Alaska Gasline Development Corporation Alaska Department of Environmental Conservation Information Request for AGDC Liquefaction Plant Permit No. AQ1539CPT01	Date: July 1, 2020
	PUBLIC	Page 1 of 4

Agency	Data Request Date	Letter Request No.
ADEC	06-18-2020 (via e-mail)	RFI-683

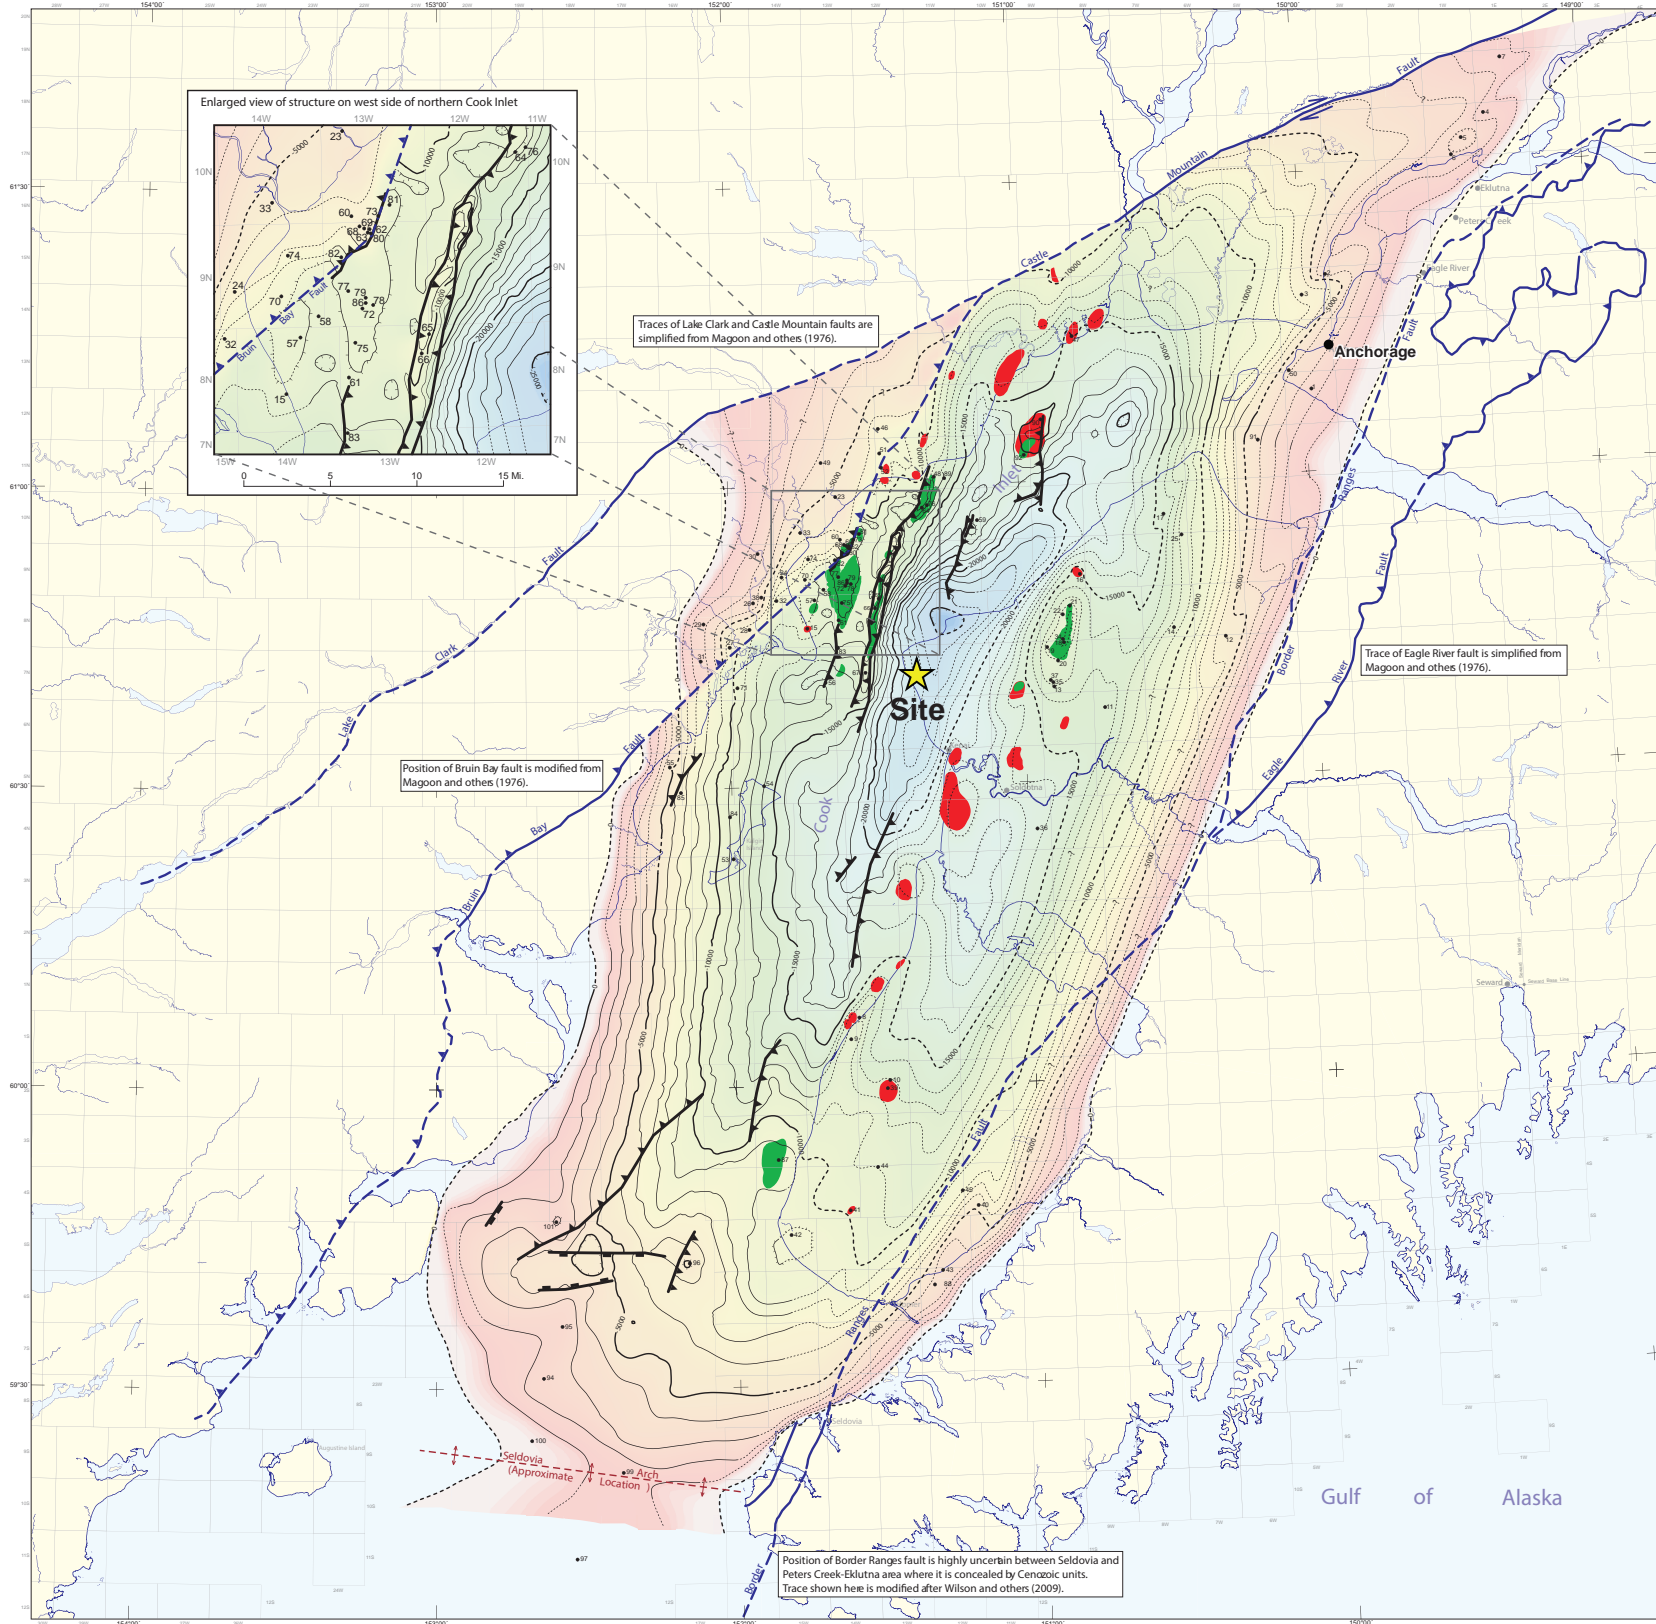
1. Justification as to why AGDC believes that the property on which the Liquefaction Facility is planned to be constructed is not suitable for injection of CO₂ and 25 miles of pipeline are required for off-site injection.
2. Site specific information for the cost of installing CCS on the ten turbines at the Liquefaction Facility, which includes a cost for total capital investment.

The installation costs for a pipeline of up to 25 miles were included in the BACT cost-effectiveness analysis to estimate costs for transportation of compressed carbon dioxide to a more suitable site for sequestration and storage. These transportation costs were estimates that assumed the technical challenges with implementing CCS could be overcome and that an acceptable location could be found for sequestration in the overall Cook Inlet regional area. Potential sites could include depleted oil and gas reservoirs that are indicated in the ADNR map figure (Plate 5) in Attachment 1.
